Work Order ID 138564

Item Name: QR Heli-Utility-Basket™, Short, HD Lid, Spacepod™ & Squirrel Cheek Comp., LH/RH

DART SERVICE INSTRUCTION

TO AMEND INSTALLATION INSTRUCTIONS D350-607-3 Rev.D,
INSTALLATION INSTRUCTIONS D350-607-4 Rev. C AND
INSTRUCTIONS FOR CONTINUED AIRWORTHINESS ICA-D350-607 REV. 6

FIGURE 1: INSTALLATION OF D4775-041 FWD STRUT

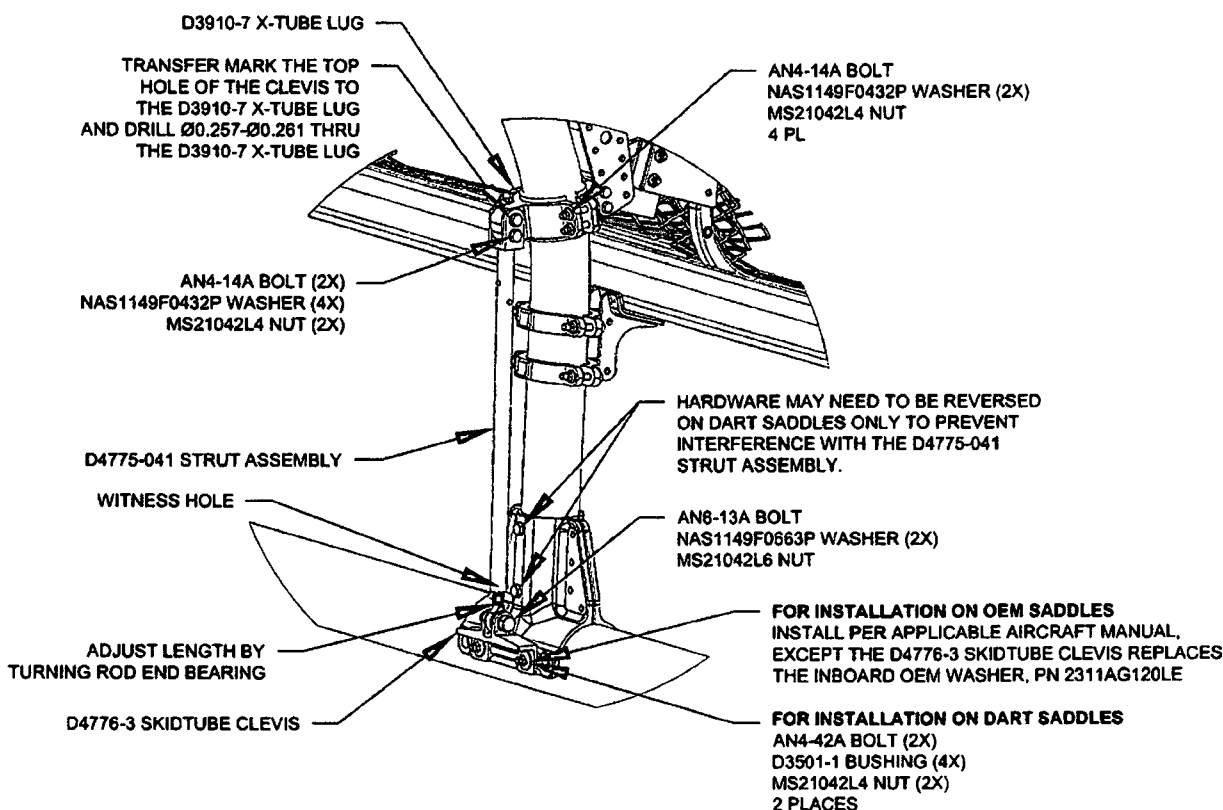
- 3.1 Substitute the Forward Lower D3910-5 X-Tube Lug with the D3910-7 X-Tube Lug as shown in Figure 1.
- 3.2 Install the forward D4775-041 Strut Assembly. Transfer mark from the upper hole on the clevis of the D4775-041 Strut Assembly to the D3910-7 X-tube Lug and drill thru the lug $\varnothing 0.257$ - $\varnothing 0.261$ as shown in Figure 1. Touch up chemical conversion coating per MIL-DTL-5541. Check the witness holes located at the bottom end of the D4775-041 Strut Assemblies to ensure that the thread from the rod end extends past the witness hole.
Torque MS21042L4/-4 nuts to 50-70 in-lbs (5.7-7.9 N-m). Torque MS21042L6/-6 nuts to 160-190 in-lbs (18.1-21.5 N-m).
- 3.3 Complete the installation in accordance with Installation Instructions D350-607-3 Rev. D or D350-607-4 Rev. C.
